CITY OF VAUGHAN

EXTRACT FROM COUNCIL MEETING MINUTES OF DECEMBER 12, 2023

-
- 4. BATTCORP HOLDINGS (VAUGHAN) LTD. AND BATTCORP II HOLDINGS (VAUGHAN) LTD. CIHA.23.002 - 661 AND 681 CHRISLEA ROAD VICINITY OF LANGSTAFF ROAD AND HIGHWAY 400**

| Application Number(s): | | CIHA.23.002 | | Planning Contact: | |

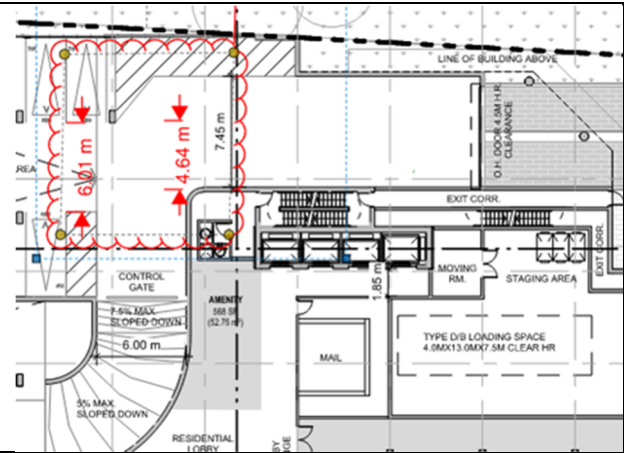
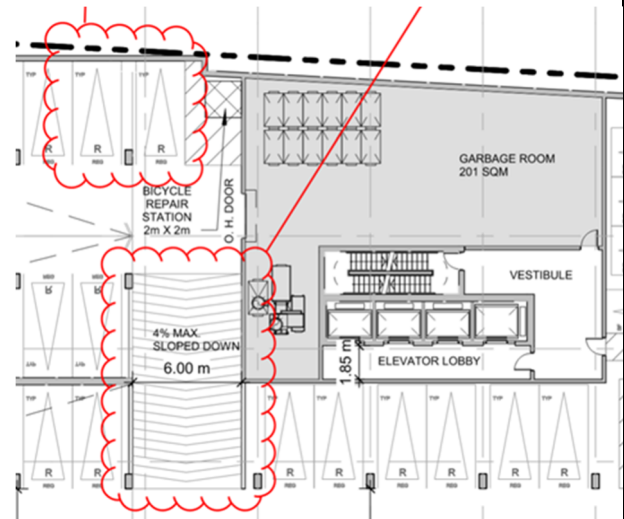
| | 10.5. | <u>General Comments</u> Please provide a visual sightline analysis to ensure there is sufficient sightline for the east access (Access #2). The TIS states there is 70m available | To be addressed at the subsequent Site Plan stage | As the location of the driveway accesses are critical to the building footprint, it is strongly recommended that this be resolved at this stage to ensure there are no major impacts to the proposed development in subsequent phases. | |

| | | however, upon staff review, there is only 60m of sightline due to the trees at the 90-degree bend, and as the TMC shows approximately 20% of p.m. peak traffic eastbound are trucks, it is anticipated the stopping sightline requirement will be greater than the 65m stated in the analysis. Additionally, it is forecasted that during the p.m. peak hour, 272 vehicles will make the EBL at the east access and a 25m left-turn lane had been recommended. With the high volumes and lack of sufficient sightline provided for the east access, Staff recommend the Applicant to consider revisions to Access #2. | | | |

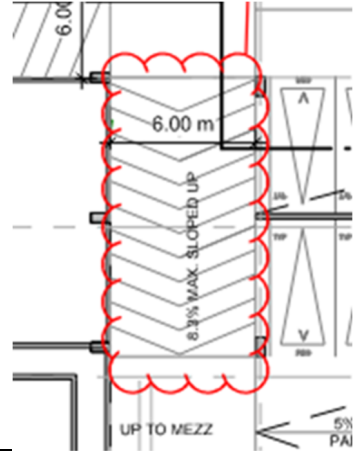
| | 10.9. | Please clarify the layout of the parking garage floors in Block 2, the footprint of each level does not match. The parking spaces on the ground floor and mezzanine do not appear to match. | To be addressed at the subsequent Site Plan stage | As the layout and organization of the underground parking garage may impact the number of parking spaces proposed, it is recommended that this be resolved at this stage to ensure there are no major impacts to the proposed development in subsequent phases. | |
| | 10.10. | Please provide clarification on Block 2 ground floor parking. It appears there are visitor parking spaces located past the control arm and along the ramp to P1. | To be addressed at the subsequent Site Plan stage | As the layout of the underground parking garage may impact the number of parking spaces proposed, it is recommended that this be resolved at this stage to ensure there are no major impacts to the proposed development in subsequent phases. | |

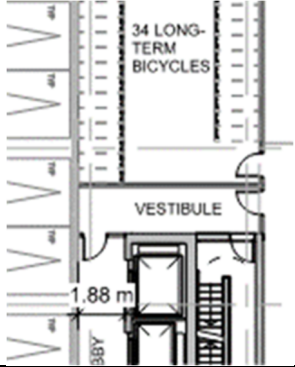
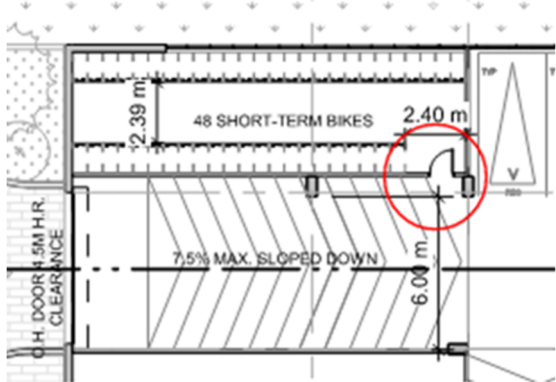
| 10.17. | <p>There are concerns with the visibility for the 2 resident parking spaces and vehicles exiting the parking garage as well as the location of the garbage staging area in Block 1. Please remove the 2 parking spaces to enhance safety.</p> | <p>To be addressed at the subsequent Site Plan stage</p> | <p>As the layout of the underground parking garage may impact the number of parking spaces proposed, it is recommended that this be resolved at this stage to ensure there are no major impacts to the proposed development in subsequent phases.</p> | |
| 10.18. | <p>Please revise vehicle ramp slope for Block 2 from ground floor to mezzanine. Grade differential shall be a maximum 7.5% transition slope over 3.65m. Provide ramp slope and length on site plan.</p> | <p>To be addressed at the subsequent Site Plan stage</p> | <p>Grade differential shall be a maximum 7.5% transition slope over 3.65m. Provide ramp slope and length on site plan as this may impact the building height or layout.</p> | |

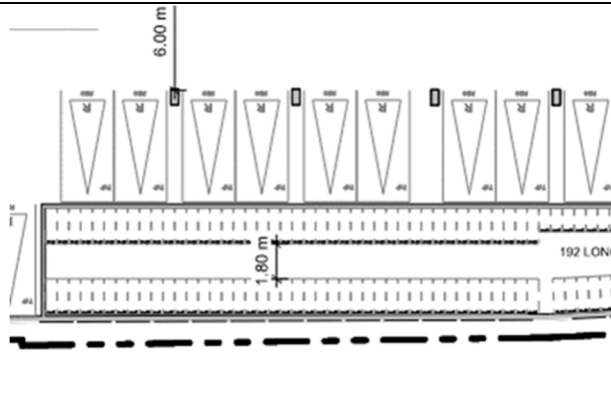
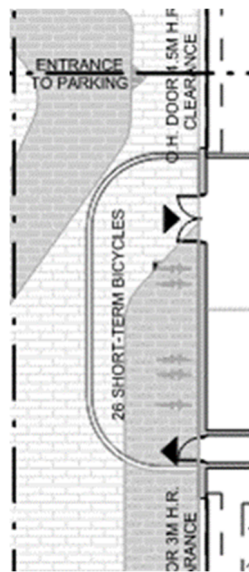
| 10.22. | TIS Table 17 shows traffic signal was not warranted for the intersection of Jevlan Drive/Chrislea Road and Silmar Drive (within 11% of being warranted). The analysis recommends implementation at the intersection as part of full buildout of the proposed development. Please note, design and implementation of the required infrastructure improvements will be the responsibility of the Owner and shall be reflected in appropriate agreement(s) with the City of Vaughan. | To be addressed at the subsequent Site Plan stage | As the traffic signal at the intersection of Jevlan Drive/Chrislea Road is only approximately 100m from the intersection of Langstaff Road and Silmar Drive, and is not warranted, Staff do not recommend the implementation of unwarranted signalizations and any proposed intersection upgrades will require circulation to and approval from the Region. Please evaluate feasibility of other improvements such as implementation of a WBR turn lane at the intersection instead to reduce the forecasted delay. | |
| 10.23. | There are a few roadways missing in Section 2 Road Network Table 3, 5. Please include information about Greenpark Boulevard/Crestmount Boulevard, Westcreek Drive/Creditview Road, and Portage Parkway. | To be addressed at the subsequent Site Plan stage | Please address at Site Plan Stage. | |
